PLANNING COMMISSION REGULAR MEETING AGENDA

Subject: 313 South Street Building Additions; Site Plan Review; Revised Plan dated 8/6/2025.

Subject: 120 S. Main Medical Office; site plan and special projects review #1; Revised Site plan and elevations dated 8/1/2025, plus supplementary information.

SITE PLAN
SCALE: 1"=20'

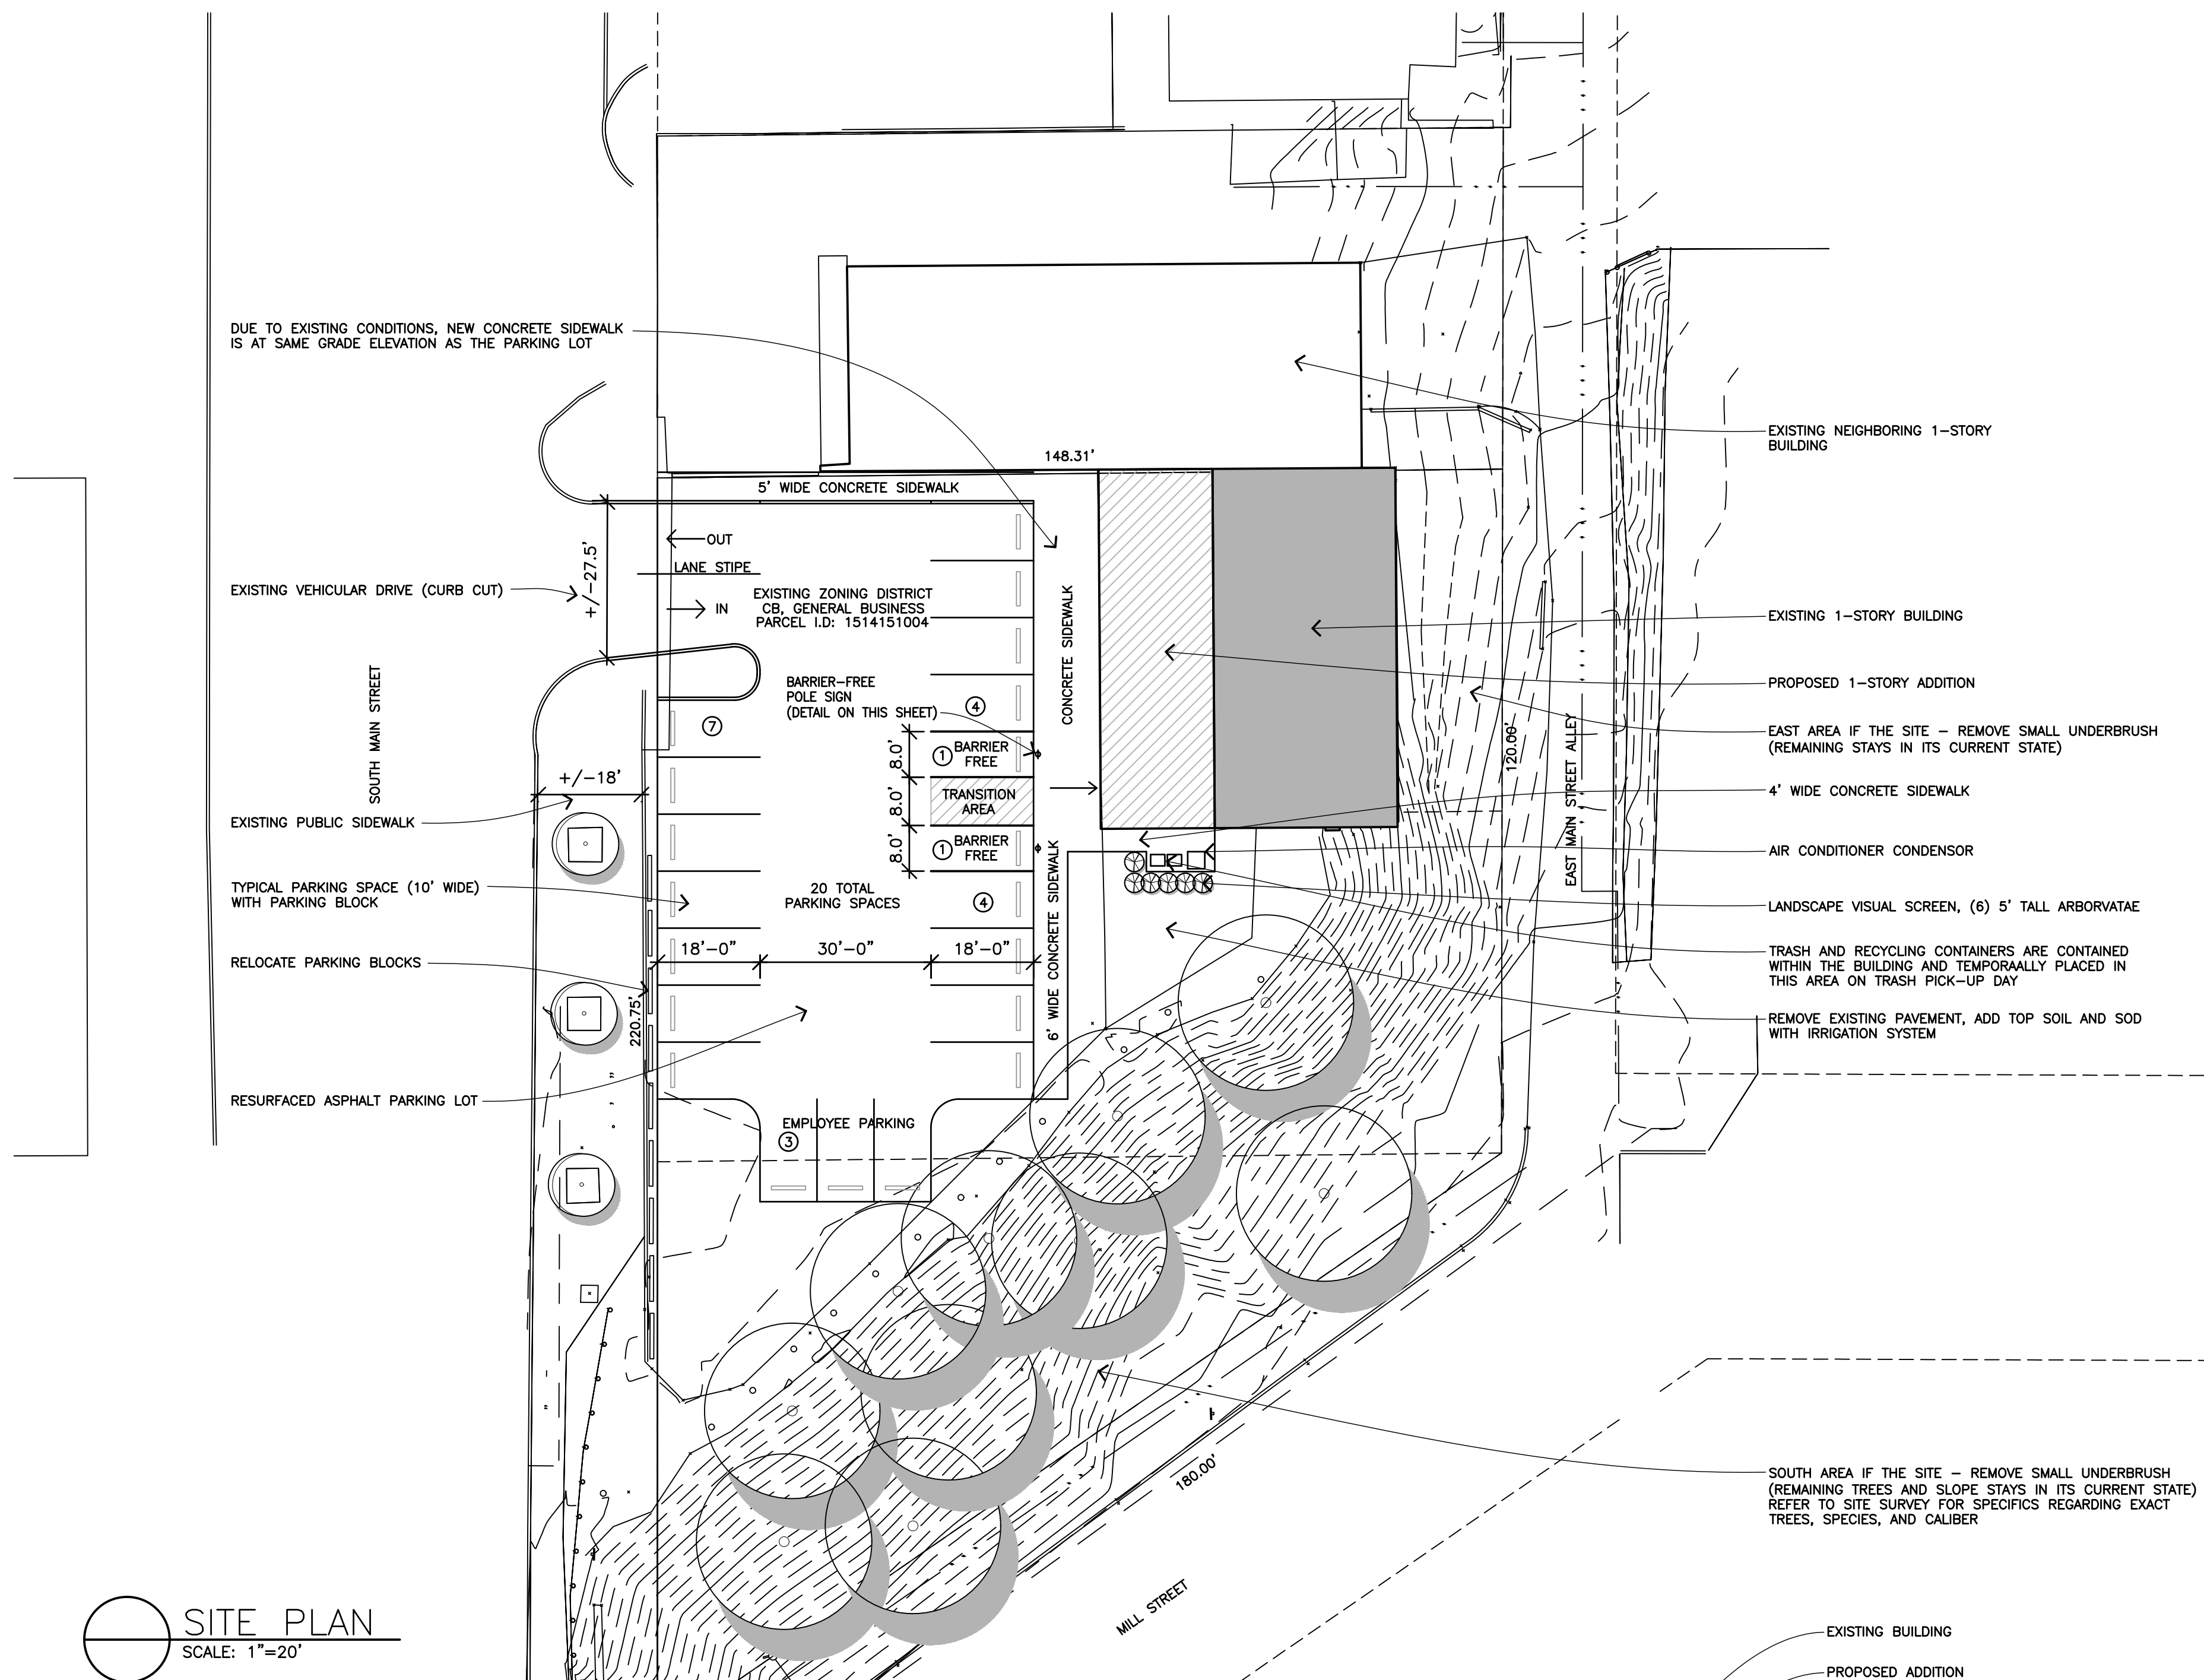
5. **Pedestrian Access.** The site has an existing 18' wide sidewalk along its Main Street frontage. The sidewalk has several DDA installed tree planted islands. The plan also notes a 11' wide sidewalk on the west side of the proposed addition which is located at the same grade as the parking lot. The sidewalk tapers to 6' width on the south side of the building to allow for safe pedestrian access from the parking lot to the building. The parking spaces abutting this sidewalk area are provided with bumper blocks to prevent vehicle encroachment onto the sidewalk and to protect the building.

width of 24 feet. The site is the first property visible while entering the downtown area across the bridge. We had recommended that the applicant create a 5-foot-wide greenbelt to be planted with ornamental grass along the west property line to provide for a separation between vehicles on-site and the pedestrians on the sidewalk. The greenbelt will also serve to cut down headlights from shing directly onto Main Street and vehicles driving on it. Many species of ornamental grasses are resilient and grow within narrow spaces. The addition of a greenbelt will greatly enhance the visual appeal of the site. The applicant has responded stating that “we prefer to have a 30’ wide drive aisle to allow for 3 car spaces at the south part of the parking lot and to allow for better exit maneuvering for those parking spaces”. Incorporation of a 5’ wide greenbelt will result in the loss of only one parking space. The site is overparked and exceeds ordinance requirements. The loss of one space is not going to impact the functioning of the site. Each space is 10 feet wide. Creating the 5’ wide greenbelt will still allow for 25 feet width for the two parking spaces on the south side (ordinance requires 19’ for 2 spaces width) along with ample maneuvering area. This recommendation is consistent with the intent of the CBD district to promote pedestrian friendly and pedestrian safe site designs, irrespective of the project being a site plan approval or a special project.

The revised renderings also eliminate the 2 planters that were previously shown on either side of the main entrance to the building. We recommend that the applicant install the planters as previously shown because it provides visual relief from the expanse of concrete (sidewalk) and asphalt (parking) which are all at the same grade. The Planning Commission has required planters with perennial plantings alongside main entrance on other sites within the CBD where it does not impede pedestrian access.

The planters flanking the front entrance are no longer proposed,

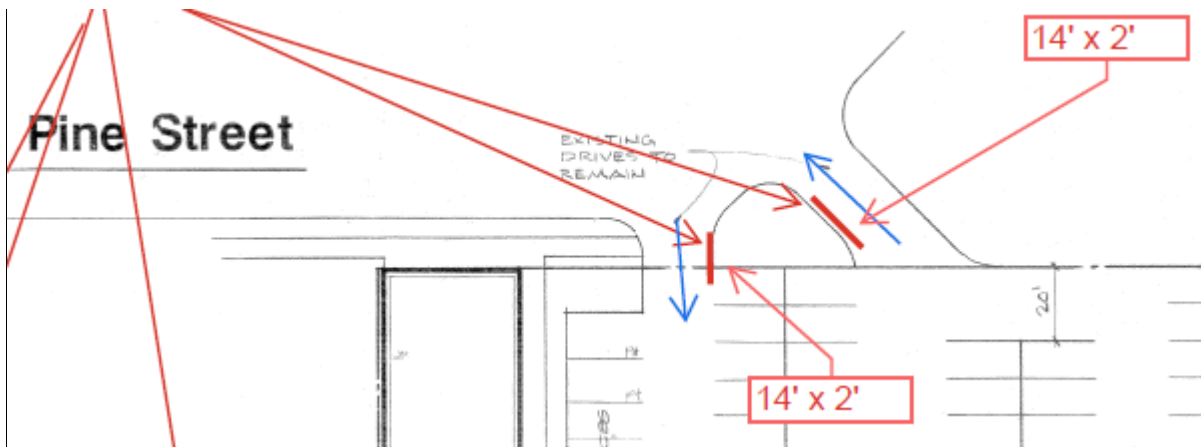
6. The 2 gate access islands on Pine Street are located within the street right-of-way. Per the drawing, the 2 islands are located **on top of the public sidewalk**. While the drawing does not show the entire sidewalk, an aerial view shows the location of the islands corresponding with the sidewalk along Pine Street. Any installation within City owned r-o-w requires City Council approval.
